8365964001 WDID NUMBER	**Gerben Hettinga** OWNER NAME	**GH Dairy No. 2** FACILITY NAME
CAG018001 NPDES NUMBER	**Ex. 6 Personal Privacy (PP)** OWNER ADDRESS	FACILITY ADDRESS
R8-2007-0001 RWQCB ORDER NO.	**Ontario, CA 91762** OWNER CITY AND STATE	**Ontario, CA 91762** FACILITY CITY AND STATE
03/07/2013 SCHEDULED INSPECTION DATE	**Gerben Hettinga** OWNER CONTACT	**Gerben Hettinga** FACILITY CONTACT
03/07/2013 ACTUAL INSPECTION DATE	**Ex. 6 Personal Privacy (PP)** OWNER PHONE NO.	FACILITY PHONE NO.
Unknown RECEIVING WATER	Ex. 6 Personal Privacy (PP) FACILITY LATITUDE	Ex. 6 Personal Privacy (PP) FACILITY LONGITUDE

INSPECTION SUMMARY

On March 7, 2013, a Concentrated Animal Feeding Operation (CAFO) inspection was conducted for Santa Ana Water Board Order No. R8-2007-0001 - 'General Waste Discharge Requirements for Concentrated Animal Feeding Operations (Dairies and Related Facilities) within the Santa Ana Region', NPDES General Permit No. (CAG018001) at GH Dairy No. 2 in Ontario, California (refer to Photo 1). The inspector met with Mr. Gerben Hettinga (Owner, GH Dairy No. 2) and Mr. Sergio Romero (Foreman, GH Dairy No. 2) at approximately 11:15 AM on March 7, 2013. Mr. Hettinga decline

Photograph 2. View facing east of lagoon No. 1 located in the central portion of the Facility. Note the lagoon did not contain a depth marker.

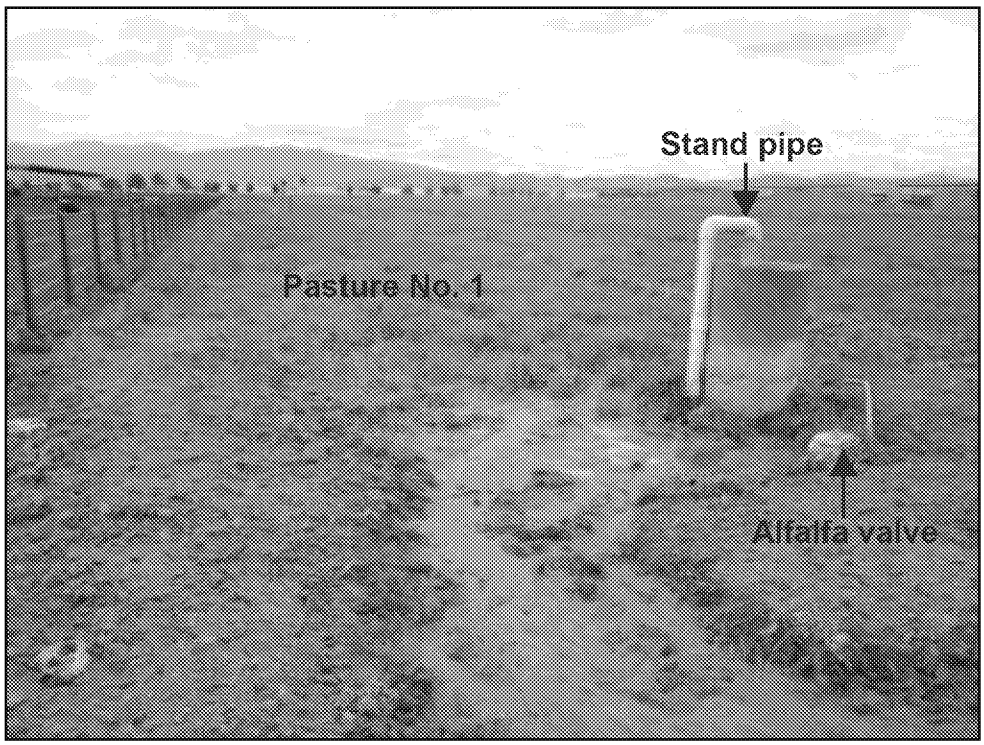
1. A depth marker was not installed in lagoon No. 1, located in the central portion of the Facility as required by Permit Attachment B - Monitoring and Reporting Program, Section I.B.1 (refer to Photo 2). This is a recurring issue identified in a previous inspection conducted on October 23, 2008.

1. The inspector observed, during the inspection, that a depth marker was not installed in lagoon No. 1 located in the central portion of the Facility as required by the Permit (refer to Photo 2). This is a recurring issue identified in a previous inspection conducted on October 23, 2008. Permit Attachment B - Monitoring and Reporting Program, Section I.B.1 states that "a marker shall be placed within each pond or impoundment to indicate the minimum capacity necessary to contain the runoff and direct precipitationof the 25-year, 24-hour rainfall event."

1. Verify whether a depth marker has been installed in lagoon No. 1
2. Verify whether the EWMP is retained onsite
3. Verify if weekly (and daily) storm water management structure visual inspections are conducted at the Facility
4. Verify whether the EWMP has been fully implemented onsite

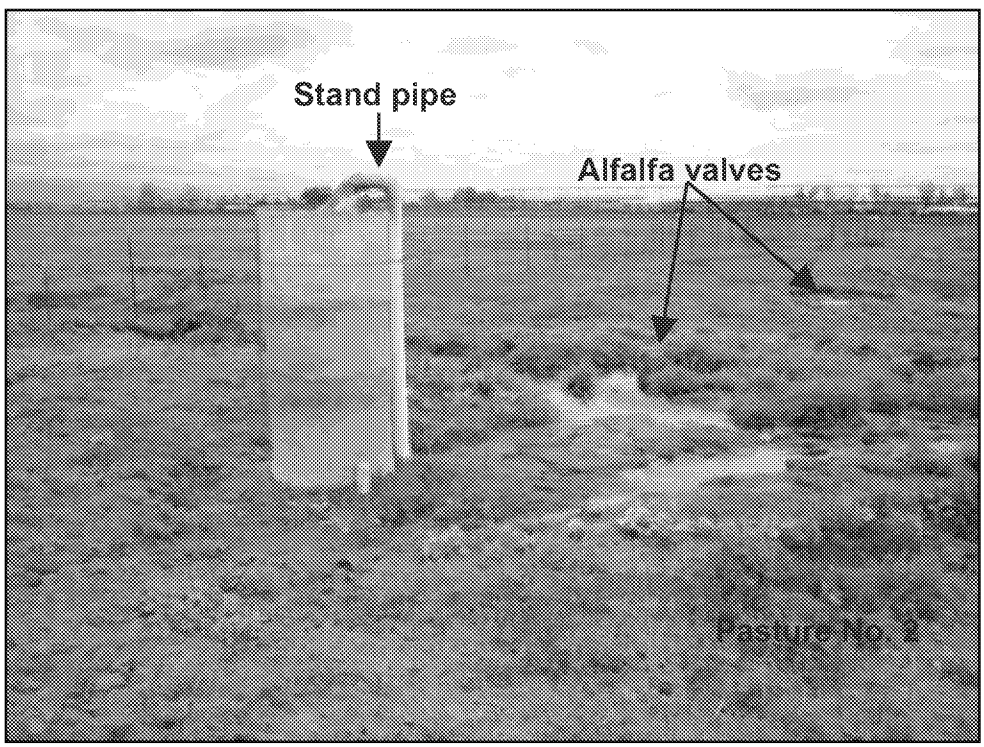
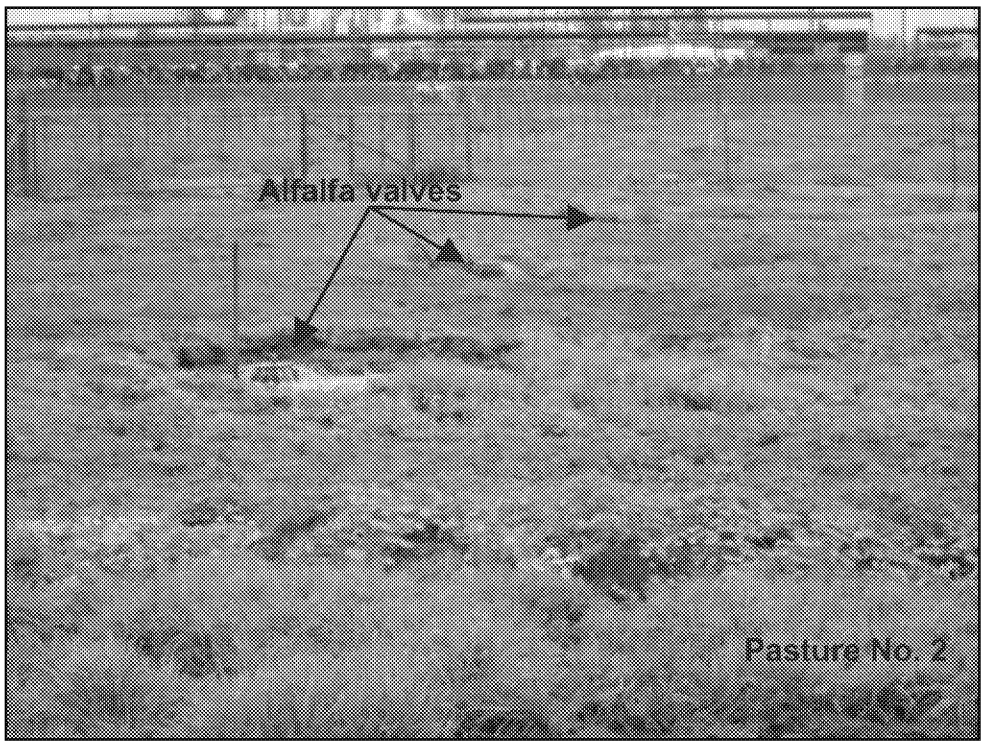
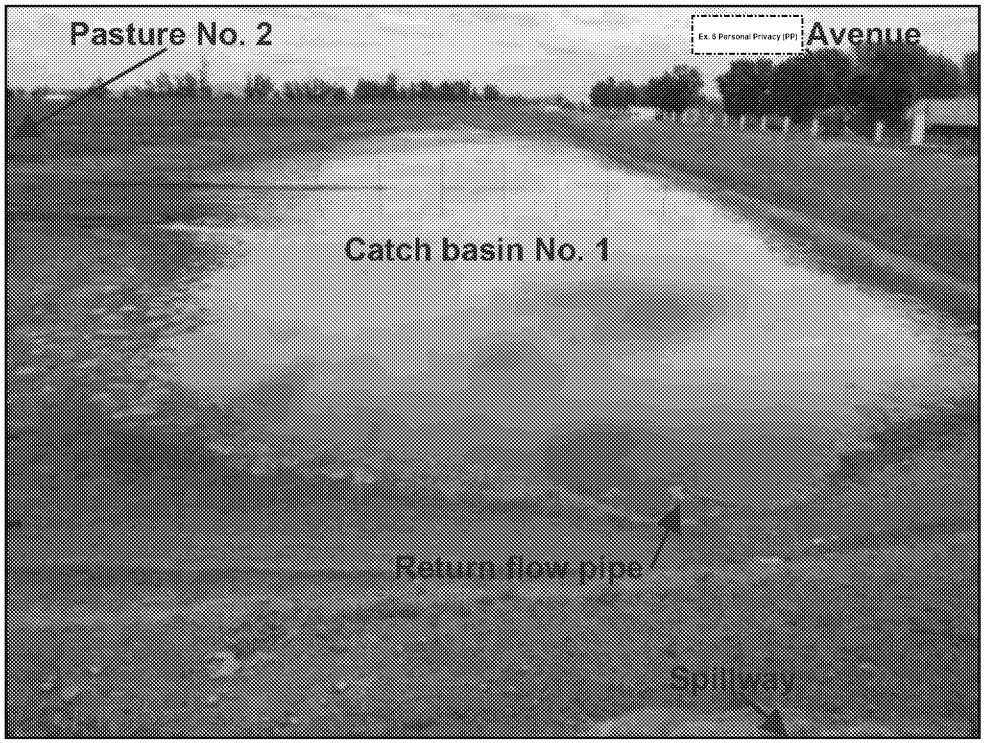
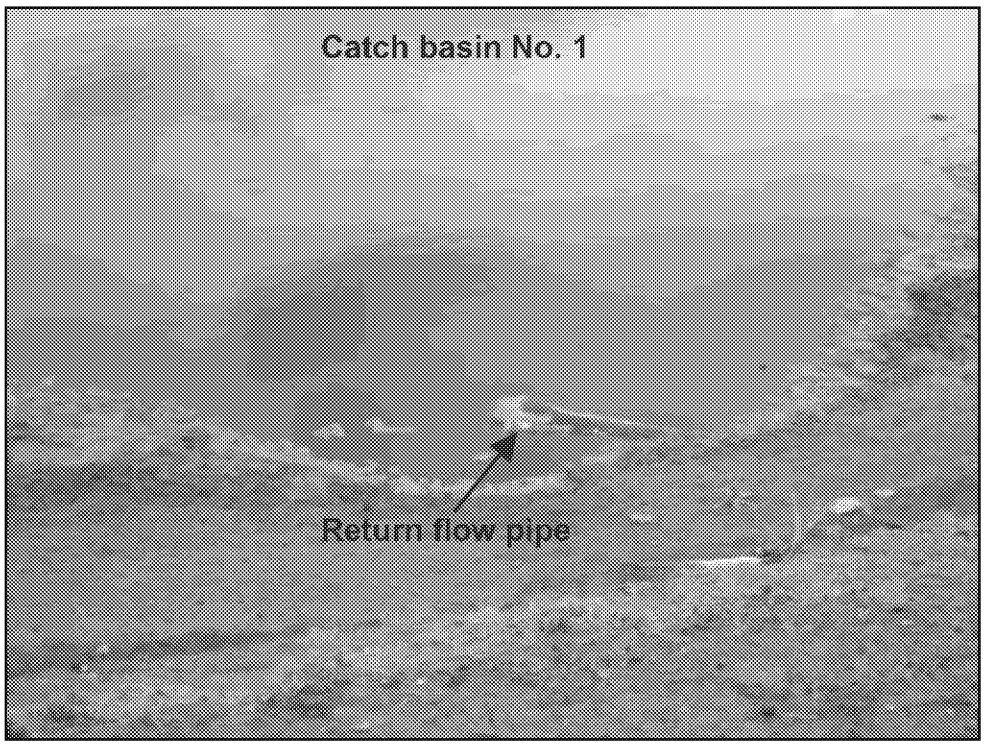
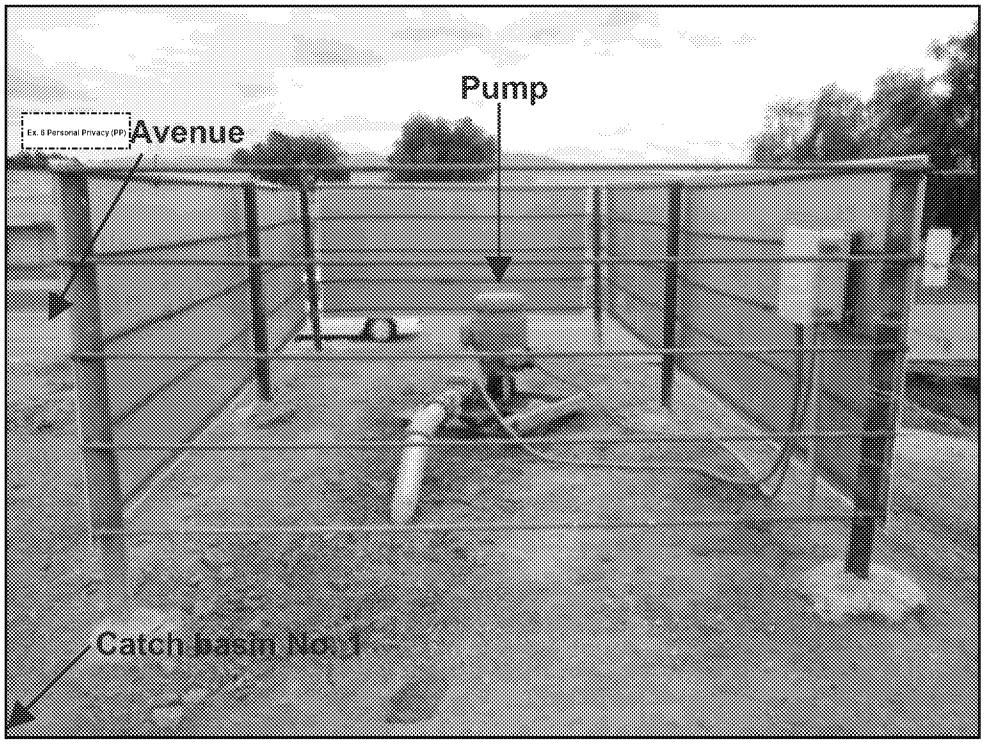
4. The EWMP was not fully implemented onsite at the Facility at the time of the inspection, as required by Provision VII.C.3.b of the Permit (refer to Photos 2 through 7).

2. The EWMP was not fully implemented onsite at the Facility as required by the Permit. Section V - 'Operation and Maintenance' of the EWMP identifies that all holding basins/lagoons be inspected weekly. In addition, the EWMP states that "daily inspections should be made upon all ponds, berms, and wastewater distribution and application equipment following the first significant rain event of each Winter season. These daily inspections should continue until large rain events cease in the Spring." Mr. Romero stated that weekly and daily storm water management structure visual inspections are not conducted at the Facility. Mr. Romero was not aware of the EWMP daily visual inspections requirements. Permit Attachment B - Monitoring and Reporting Program, Section I.B stated "all containment structures, including but not limited to, ponds, berms, and wastewater distribution lines, shall be inspected at least once a week during the entire year and at least once each 24-hour period during a storm event in which rainfall exceeds 0.5 inches in 24 hours. The findings of these inspections shall be documented on the attached CAFO Weekly Storm Water Management Structure Inspections Log Sheet (Attachment 1[of the Permit])." In addition, Provision VII.C.3.b of the Permit states that "the discharger shall develop and fully implement an Engineered Waste Management Plan (EWMP) acceptable to the Executive Officer". As a result of not conducting weekly and daily inspections outlined in the EWMP, the Discharger was not fully implementing the approved EWMP. The Discharger shall fully implement the approved EWMP as required by Provision VII.C.3.b of the Permit.

3. The EWMP was not fully implemented onsite at the Facility as required by the Permit. Section V - 'Operation and Maintenance' of the EWMP requires that the Discharger "disc percolation areas (fields) to about 18 inches to assure maximum percolation during wet seasons…All of the disposal areas should be disked at least once each year." Specifically, Mr. Romero informed the inspector that the disposal pastures are not disked or plowed to promote percolation and infiltration. Provision VII.C.3.b of the Permit states that "the discharger shall develop and fully implement an Engineered Waste Management Plan (EWMP) acceptable to the Executive Officer." As a result, the Discharger was not fully implementing the approved EWMP. The Discharger shall fully implement the EWMP as required by Provision VII.C.3.b of the Permit.
